**Service Bulletin No.:** DAC1-24-01 Rev 1

**Title:** Generator Lower Attaching Bolt Replacement

**2. Effectivity:** DA20-C1 aircraft from S/N C0001 to S/N C0031.

Figure 1: Generator Installation

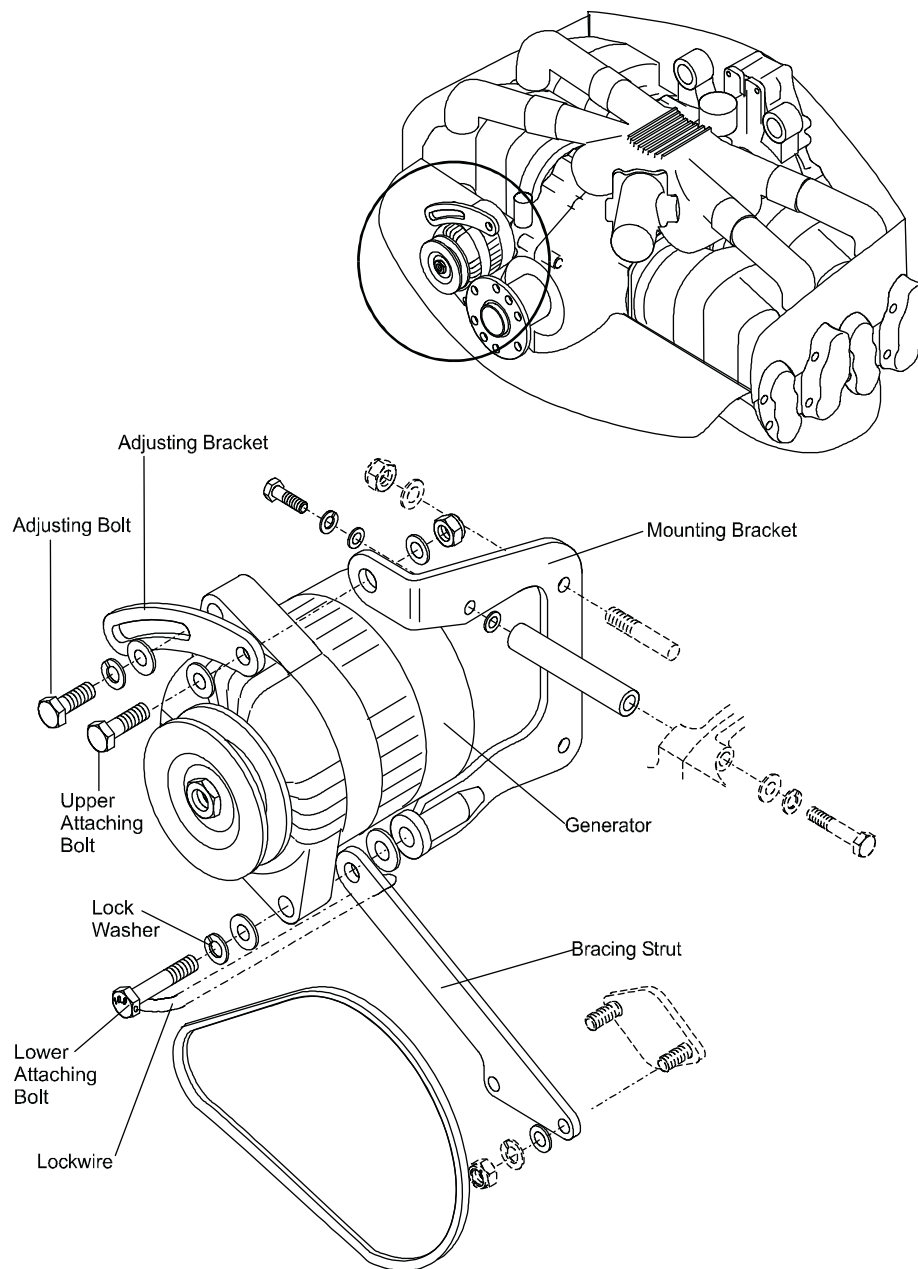
**3. General:** Excessive generator belt tension can result in fatigue failure of the generator lower attaching bolt. This Service Bulletin (SB) addresses replacement of the existing bolt with a higher strength bolt.

10.1 Remove and discard existing lower attaching bolt and lockwasher.

10.2 Install and hand tighten new attaching bolt with 222 Loctite (applied to shank and threads) and new lockwasher (ensure "10.9" is embossed on bolt head).

10.6 Lockwire lower attaching bolt to bracing strut as per figure 1.NA.
